AMENDED IN RED

REVISION			DATE	ISSUE DETAILS		DRAWN	DESIGN	DRAWN	STATUS	SCALE		CLIENT	PROJECT		DRAWING TITLE				
1			27.10.21	ISSUED FOR INFORMATION		CH	CH		PRELIMINARY NOT FOR CONSTRUCTION	1:500				WEINAM CREEK GENERAL		OVERALL LAYOUT PLAN SHEET 2 OF 3			
2			04.11.21	ISSUED FOR INFORMATION		CH	CH			10 5 0 10 20m A1									
3			03.12.21	ISSUED FOR INFORMATION		CH	CH			1:1000									
								DESIGN

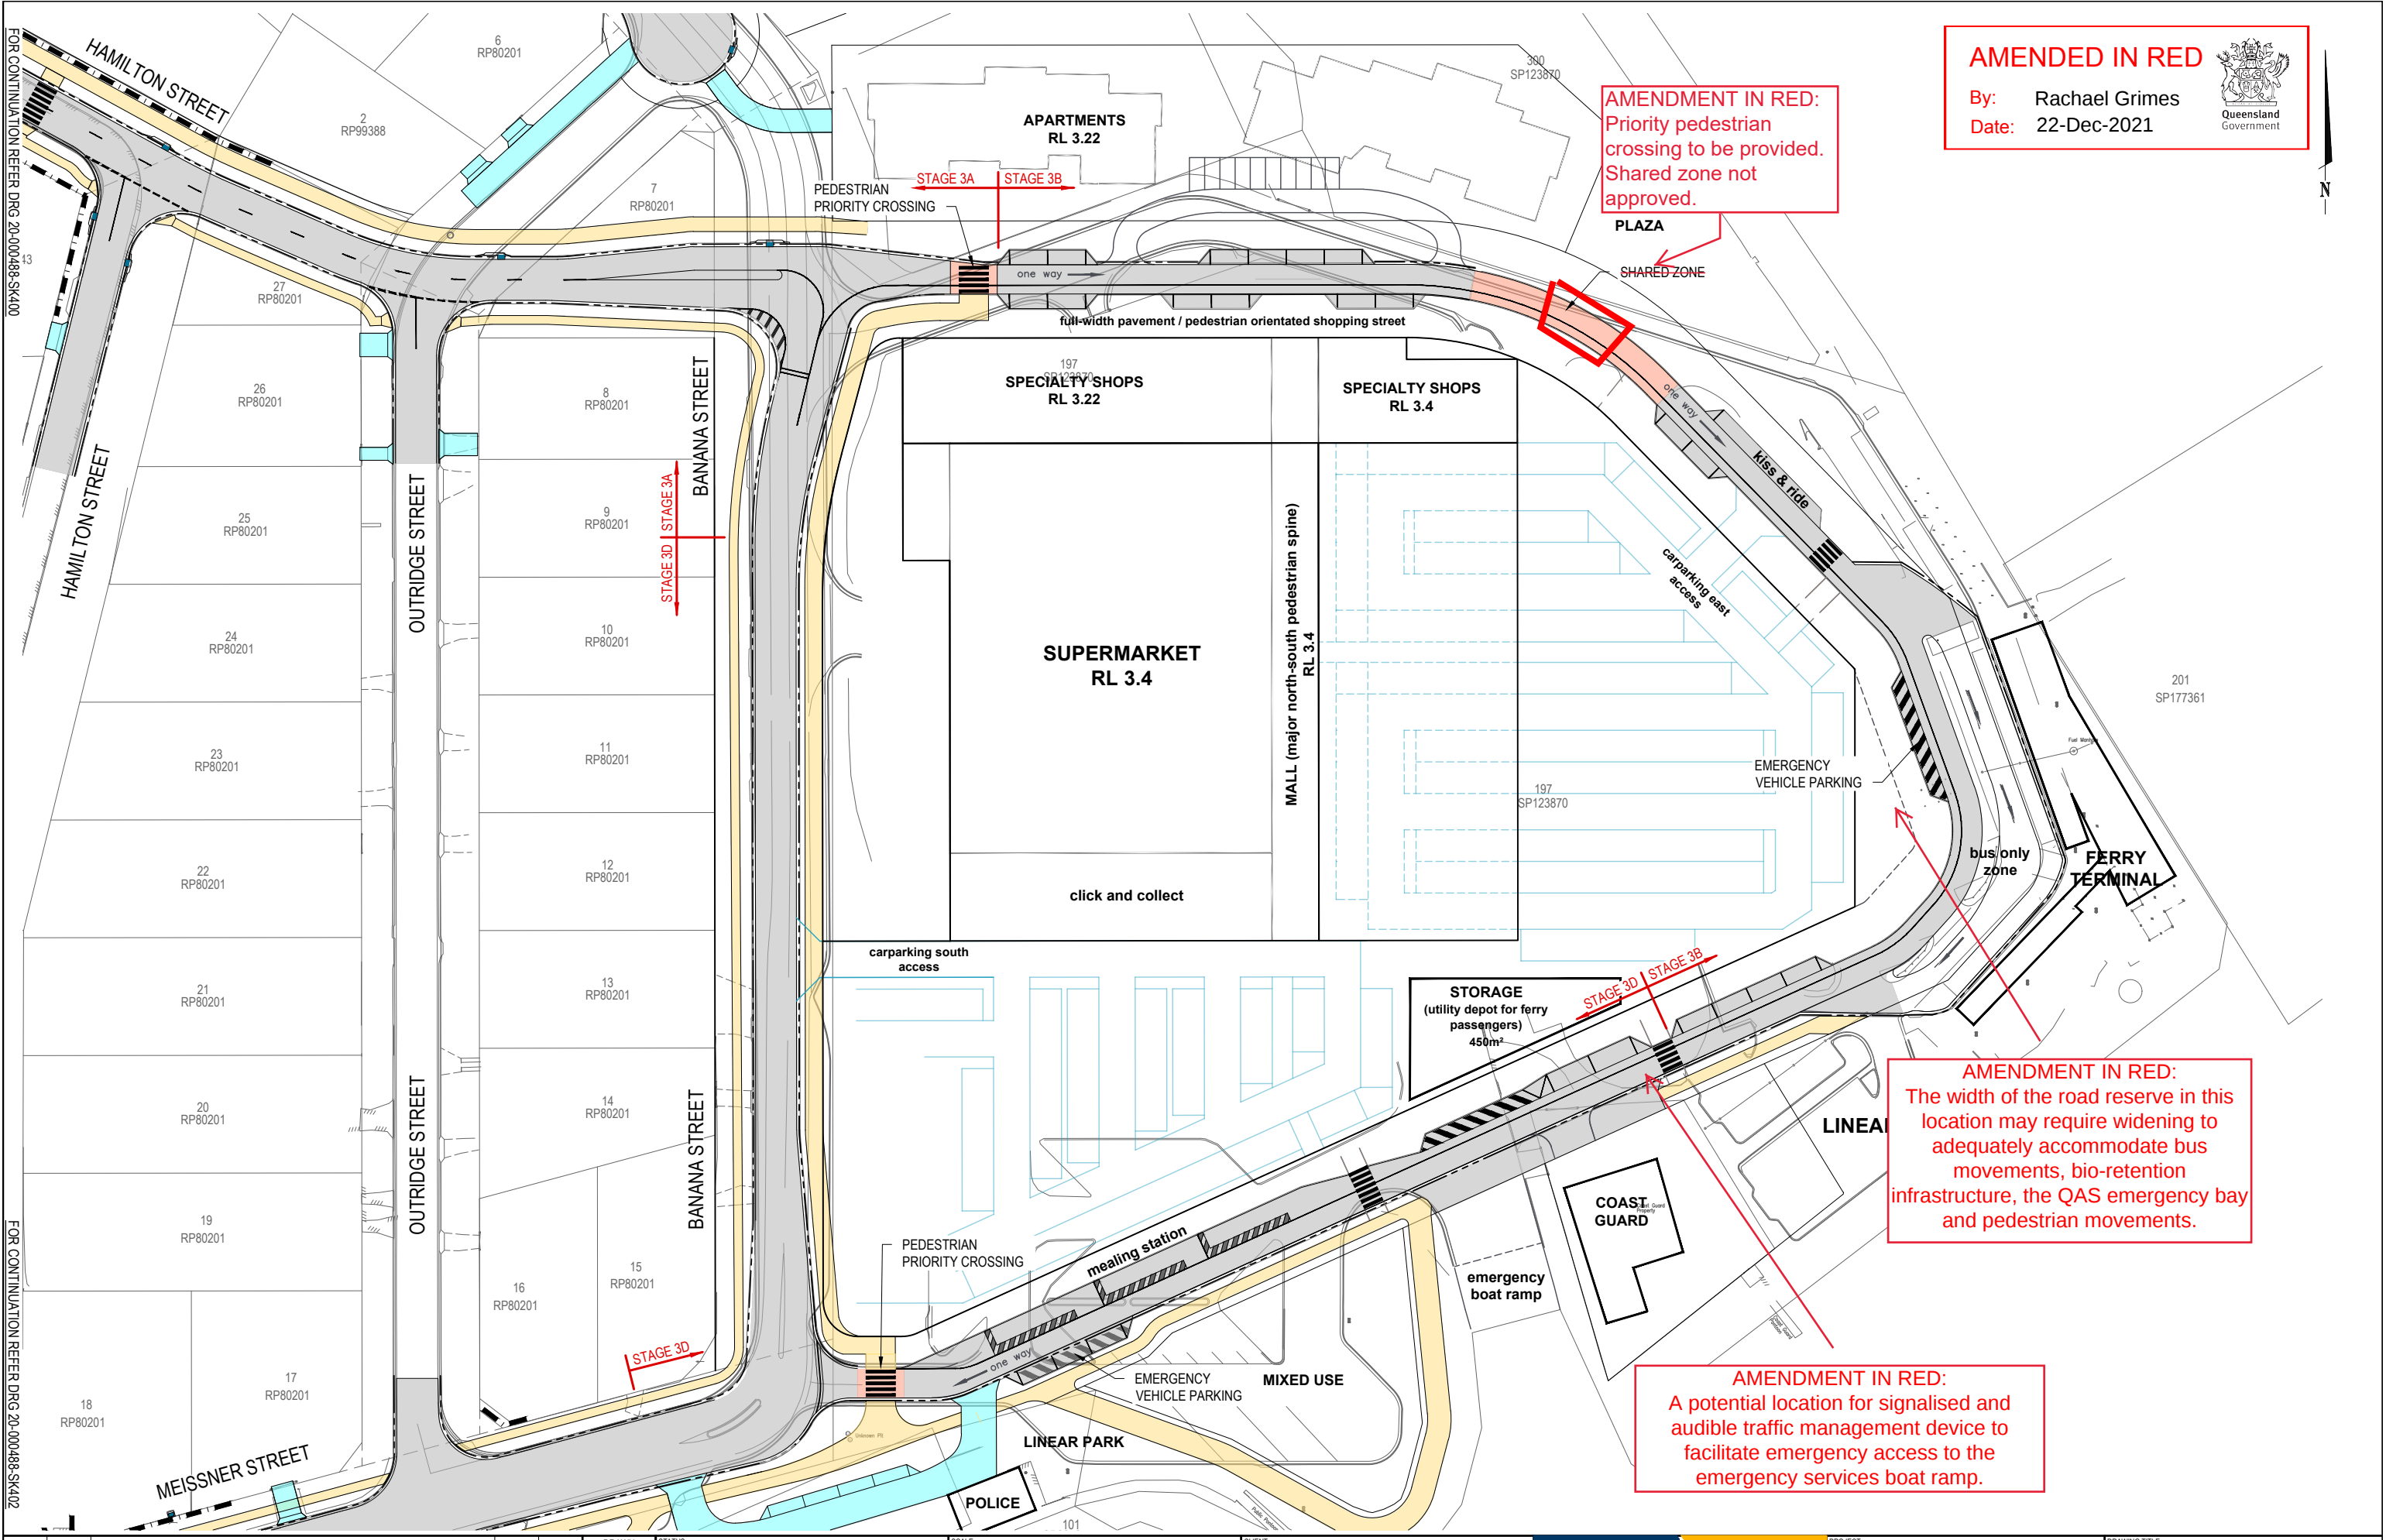
AMENDMENT IN RED:
Priority pedestrian crossing to be provided. Shared zone not approved.

AMENDMENT IN RED:
The width of the road reserve in this location may require widening to adequately accommodate bus movements, bio-retention infrastructure, the QAS emergency bay and pedestrian movements.

AMENDMENT IN RED:
A potential location for signalised and audible traffic management device to facilitate emergency access to the emergency services boat ramp.
